Staff Report & Recommendation

Design Review Board

SUBJECT: DRB18-0276
1000 South Pointe Drive –Murano at Portofino Condominium

Exhibit "A"

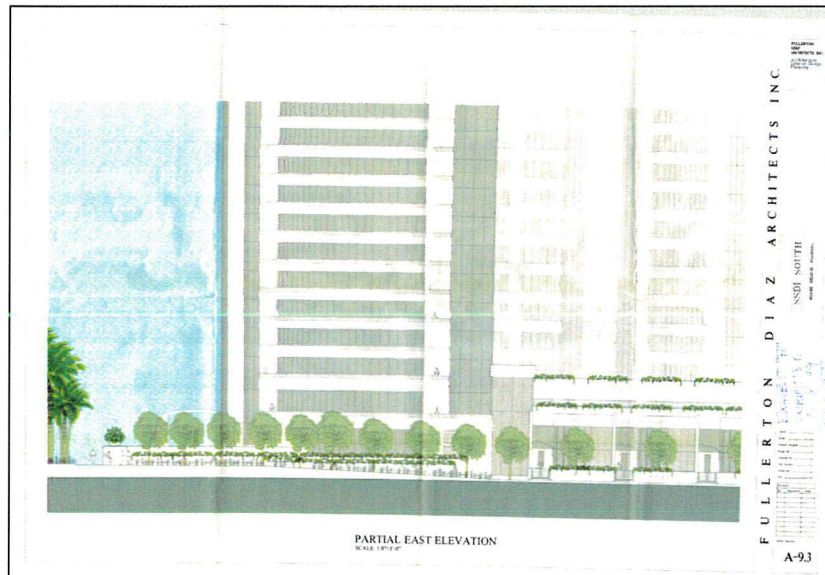
The applicant is proposing to delete the following condition of the May 18 1999, Final Order:

Condition B.1(k): The proportions of glass and white aluminum on balconies shall comport approximately with the proportions shown on Exhibit "A", submitted at the meeting.

As enumerated in the 1999 final order for the project, “*Condition B.1(k): The proportions of glass and white aluminum on balconies shall comport approximately with the proportions shown on Exhibit “A”, submitted at the meeting.*” Based on the analysis above, staff is supportive of the deletion of Condition B.1(k) in the recorded Final Order.

Condition B.1(k): ~~The proportions of glass and white aluminum on balconies shall comport approximately with the proportions shown on Exhibit "A", submitted at the meeting.~~

Exterior Images of the failing adhesive of the panels

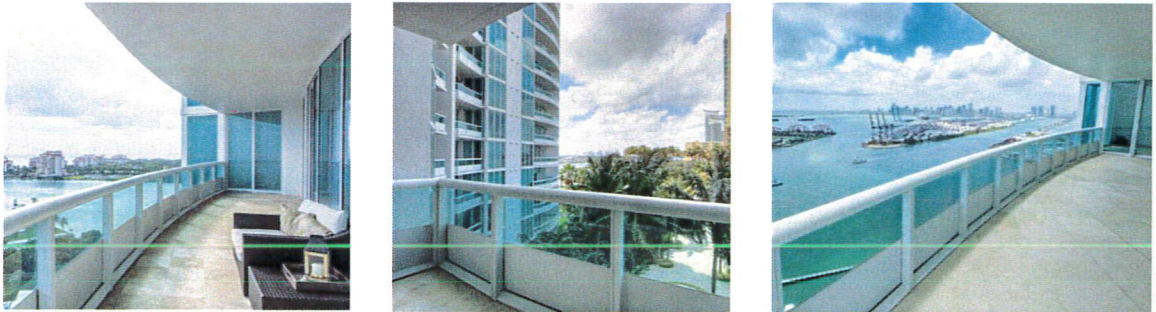
The applicant is proposing exterior façade modifications to existing balconies of the 37-story Murano at Portofino bayfront tower. Specifically, the applicant is requesting an after-the-fact design approval to allow for the all-glass railings, where previously the glass railings were affixed with lower metal panels to both sides. The white metal panels had originally occupied half of the 42" high railing systems and are found throughout the exterior balconies on all elevations.

A permit for emergency railing repair was approved by the City under Building Permit No. B1602380. The removal of the metal panels was a life safety concern as the panels were "falling off the building" at random locations and areas. A notation by the Planning Department was added that the applicant would be required to appear before the Design Review Board (DRB) should the applicant not reinstall new panels to match the original configuration. Due to life safety concerns, the permit was issued to remove the glass panels from the balcony railing system, to detach the metal panels mounted with industrial adhesive to both sides of the glass. Once the "kick plate" break panels are removed and the gaskets replaced, the glass panels are to be cleaned, prepared, and reinstalled within the balcony framing systems with the existing cap top railing to remain. This approved permit was subject to an application to the DRB for approval of the modified balcony design by May 09, 2016, which the applicant failed to do.
